**IN THE MATTER OF ROYAL COMMISSION OF INQUIRY INTO BUILDING  
FAILURE CAUSED BY CANTERBURY  
EARTHQUAKES**

**AND IN THE MATTER OF THE CTV BUILDING COLLAPSE**

**STATEMENT OF EVIDENCE OF MURRAY LIONEL JACOBS  
IN RELATION TO THE CTV BUILDING**

**Diagram 1: Plan of building showing the centre of mass as the dot in the centre of the floor plate and the centre of stiffness shown as the collection of dots in the North Core wall (stair well)**

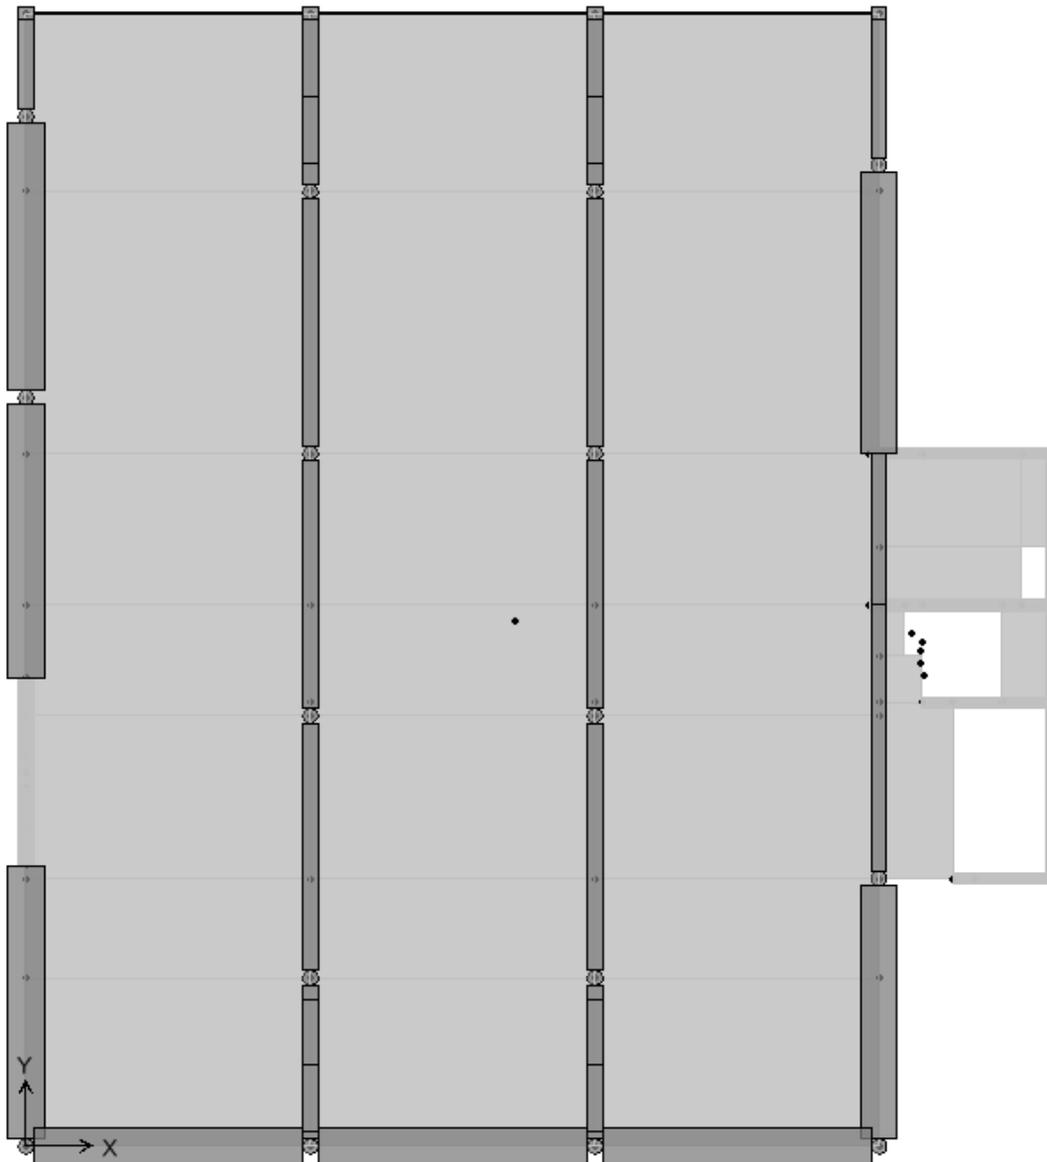
12. The CTV Building does not comply with this instruction. The primary resisting elements in this structure are asymmetrical in the East West direction. In the North South direction the eccentricity is less. The main resisting element is the concrete core wall between lines 4 and 5 situated completely outside the main floor plate envelope (**North Shear Core**). There is a smaller much less stiff coupled shear wall on the south side of the building on line 1 (**Coupled Shear Wall**).

13. The diagram shown below, taken from the Hyland/Smith report, shows the large separation of the centre of mass from the centre of stiffness and consequently rotation. The Building will rotate about the centre of stiffness during an earthquake and place a greater demand on some of the columns, especially those further away from the centre of stiffness.

Diagram 2 shows a vertical section through the beam column joint. Note: effectively one tie 6 mm in diameter that is placed in the joint. The bent up bars from the precast beams have limited anchorage in the joint zone.

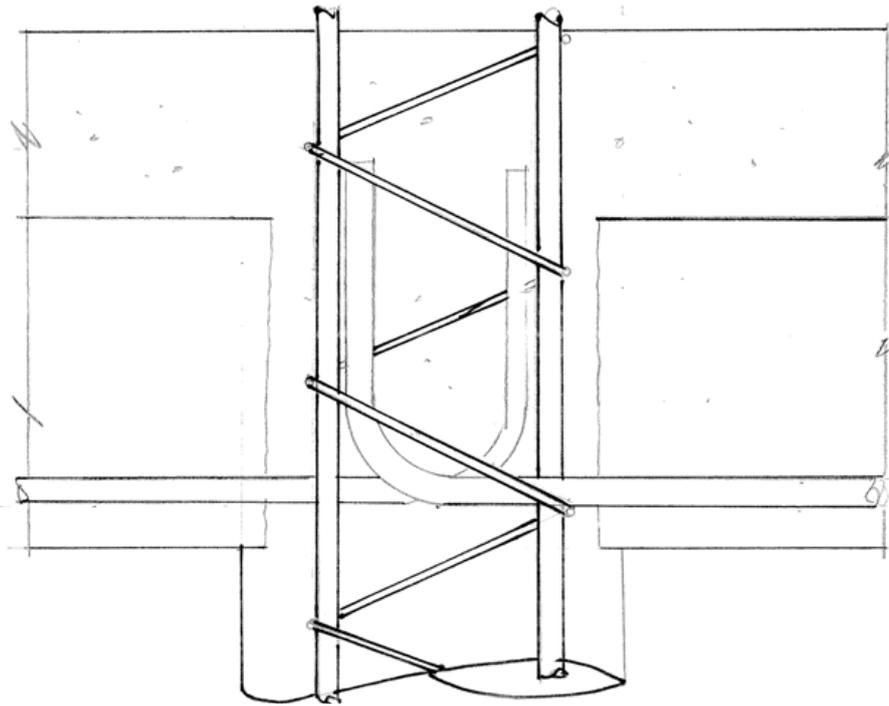
18. The columns in the CTV building could be expected to fail in an earthquake because of insufficient ties. The columns were reinforced with 6 longitudinal bars 20 mm in diameter contained by 6 mm spiral ties at 250 mm centres 150 radius inside. The spirals continued at 250 mm centres through the joint between the floor beams and the column. The 6 mm ties at 250 mm centres are not sufficient to provide ductile action in the columns.

19. There is considerable congestion in the joint and it is difficult to see how the precast beam bottom reinforcement could be placed with the spiral in position as shown. The structural drawings No S14 show the spiral stopping under each beam and then starting again above the line of the bottom of the beam. There is no note on the drawings to lap the spiral bars as would be required to provide continuity of action.

52. The joint shown in my diagrams S2 and 3 has not been designed to meet these requirements. The provision of one 6 mm diameter spiral does not provide the shear resistance needed to transfer the internal forces generated in a beam-column joint.

**Diagram 4 showing frame line F with North Shear Core. The frame is joined to the shear wall by the slab. Note the notch in the base of the wall. The columns in frame line F have not been detailed for ductile action.**

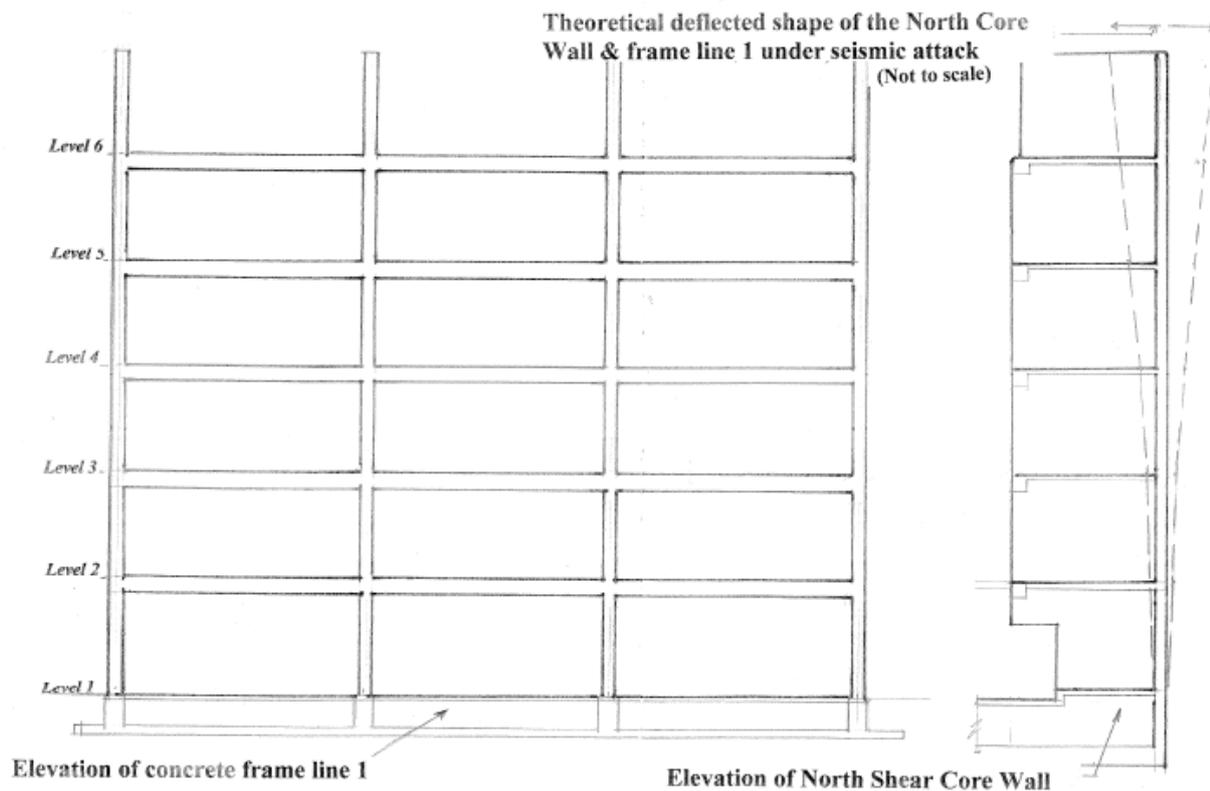
30. The same question applies to the frame on Line F, which runs in the North-South direction, except these frames are even more likely to fall into the category mentioned in the Commentary to NZS 3101, (C3.5.14.1) as the shear wall in the North-South direction is more slender:

31. The reduced wall section of the North Shear Core shown in diagram 4 between Levels 1 and 2 will mean that the resulting rotation of the wall will be increased. The moment of inertia is under half for the wall at this level compared to the case if the notch was not present. I would consider this to be a slender shear wall in this direction and C3.5.14.1 would apply.

**Diagram 5 showing Shear Core North Wall. Shaded areas show connection of slab to rear of wall line (5). The areas with cross lines are opening for stairs, lifts and ducts**

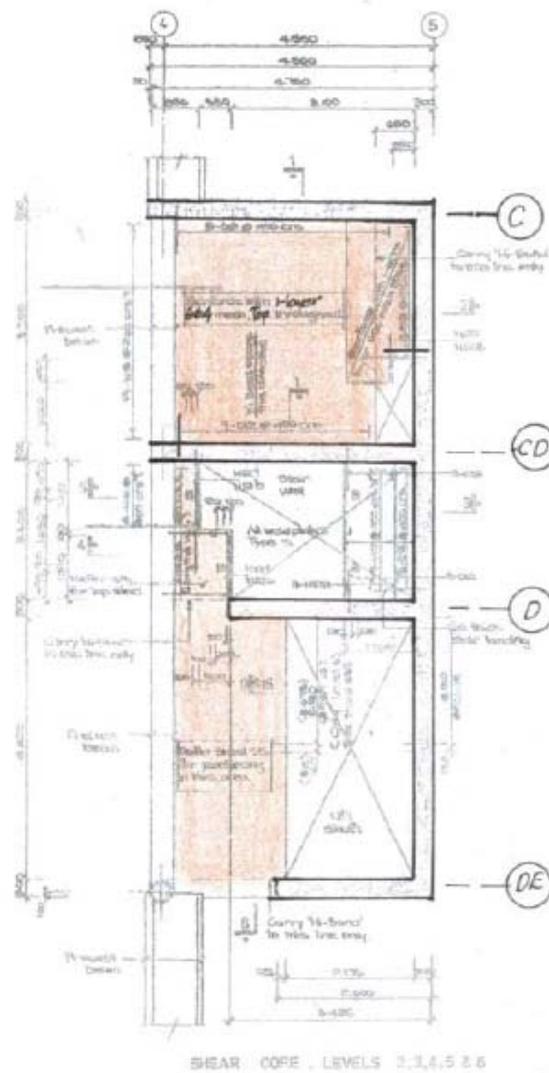
44. The connection to the North Shear Core is limited. In the East- West direction the rear wall of the shear wall is 11.5 meters long and provides the shear capacity in this direction for the wall. However, the connection to this rear wall is only by a slab approximately 3.75 meters wide and 4.5 meters deep. There is also a hole in this slab adjacent to the rear wall resulting in only a 2.35 meter slab connection directly to the wall. This slab has one layer of 664 mesh top throughout as reinforcing, plus short starter bars from the return wall at Line C and Line C/D. This is below the code requirement for steel in a slab.

45. In the North- South direction the two walls on Lines C and C/D are connected by 19 D 12 diameter bars in the slab. The two return walls D & D/E of the North shear wall do not appear to be connected to the main floor slab. The effect of this would be to induce further eccentric behaviour in the wall under North-South seismic action. I have been advised by Counsel Assisting that some attempt was made to connect these walls to the slab at a later date.
